# 1987 - 1991 Corvette: Service Bulletin: 4L60 Low & Reverse Clutch New Plate Available

**Subject:** 4L60 LOW & REVERSE CLUTCH NEW WAVE PLATE IS AVAILABLE

**Bulletin Number:** 91-186-7A - (01/29/1991)

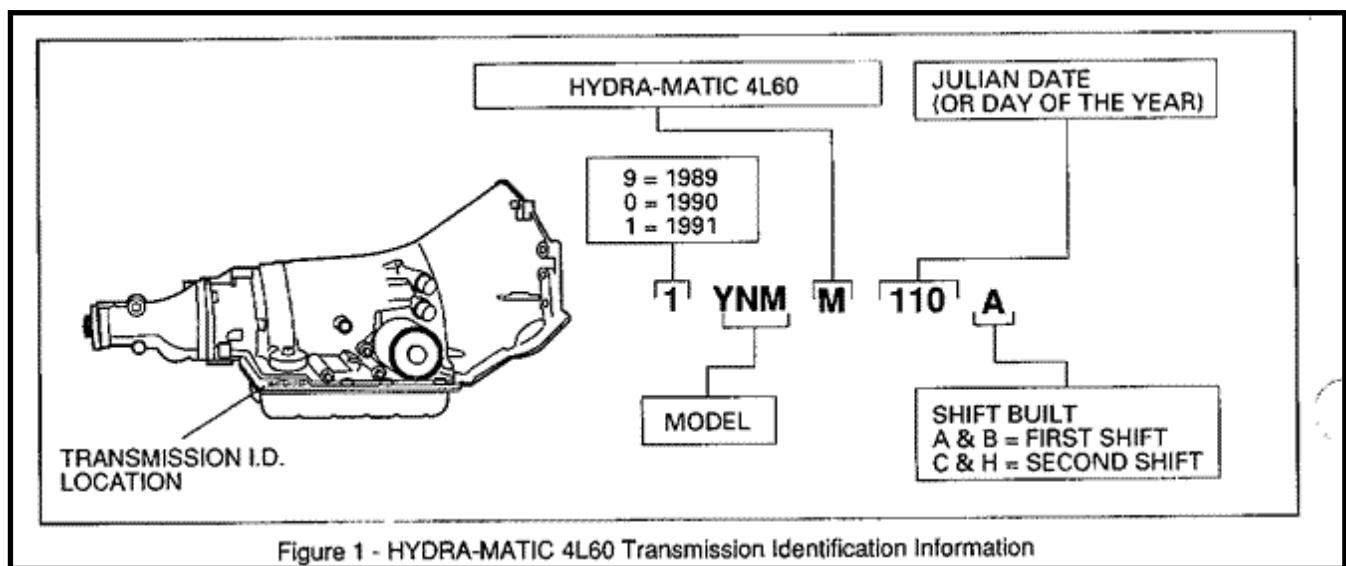
**DATE OF PRODUCTION CHANGE:** (Figure 1)

----- Beginning March 28, 1990 (Julian Date 087), all HYDRA-MATIC 4L60 transmissions were built using the new low and reverse clutch wave plate.

Figure 2 - Lo And Reverse Clutch Waved Plate

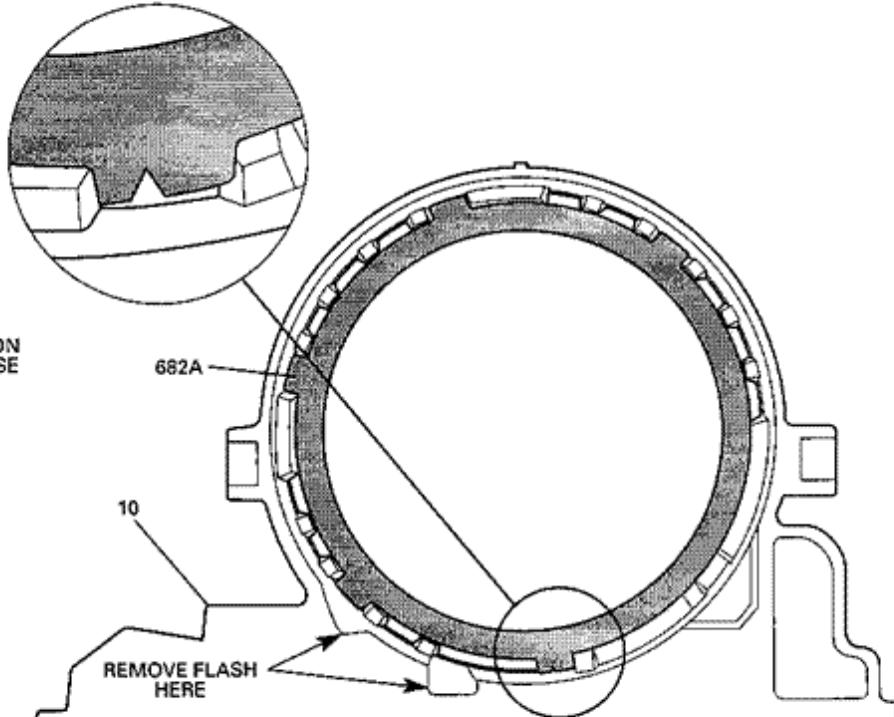
**SERVICE INFORMATION:** (Figure 2) ----- Low and Reverse Clutch failure can be caused by case casting flash interfering with clutch plate travel. A new wave plate is now available which will alleviate this condition. This new plate can be used to service any Hydra-matic 4L60 transmission produced after February 9, 1987 (Julian Date 040).

When installing the new wave plate, check for any case flash that may be present in the low and reverse grooves, and use a metal file to remove. See Figure 2 for case location information.

REMOVE FLASH  
HERE
